QUESTIONS AND STATEMENTS FROM THE PUBLIC

TO THE PLANNING COMMITTEE ON 3rd October 2023

Item 6 - 23/00195/FUL – Garages Rear of 27 Medway Close, Chelmsford, Essex

Item 7 - 23/01167/FUL – Little Cleatop, South Street, Great Waltham, Chelmsford, Essex, CM3 1DP

Diagram 15.3 Turning facilities

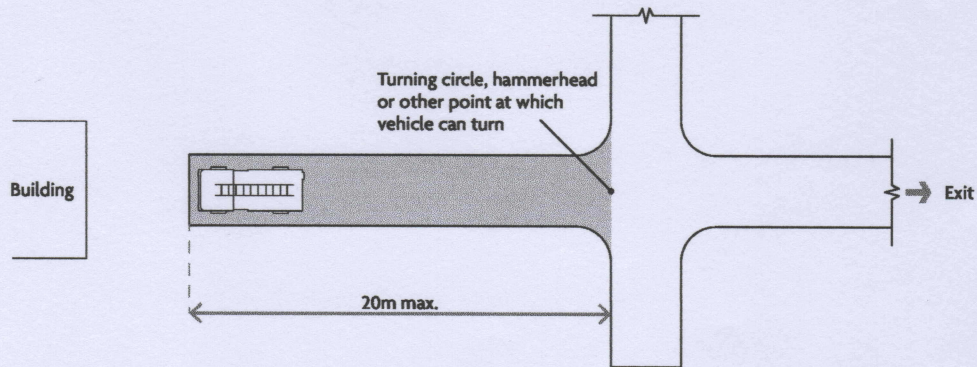
* Please note that the Council has used the wrong width (2.4m instead of 2.98m) for the tracking diagrams on p35 of the Transport Statement.

See para 15.10

Fire and rescue service vehicles should not have to reverse more than 20m from the end of an access road.

On current plans the fire vehicle would have to reverse more than 20m from outside plots 1, 2 + 3.

Back of houses at more than 30 degrees to one another. Separation to be reduced to 15 metres from the nearest corner

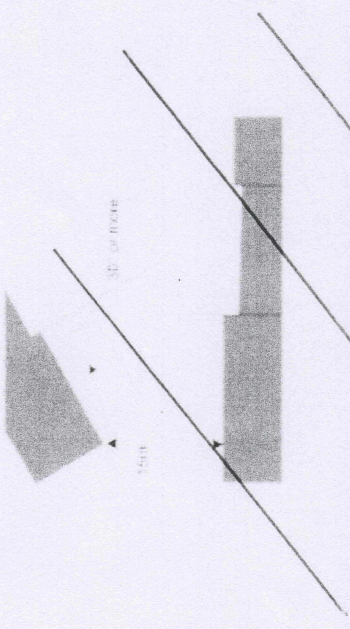
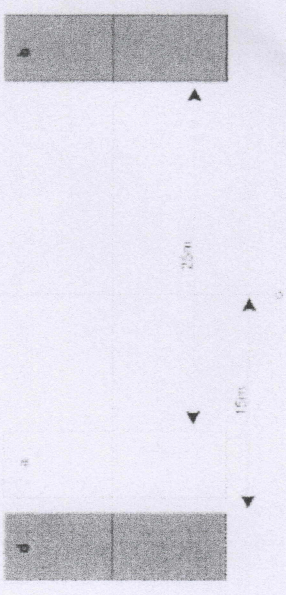
Where new development backs on to the rear of existing housing, existing residents are entitled to a greater degree of privacy to their rear garden boundary. Where the rear faces of the new houses are approximately parallel to those of the existing homes, the rear of the new houses may not encroach any closer than 15m to an existing rear boundary – even though with a closer encroachment, 25m between the rears of the houses could still be achieved.
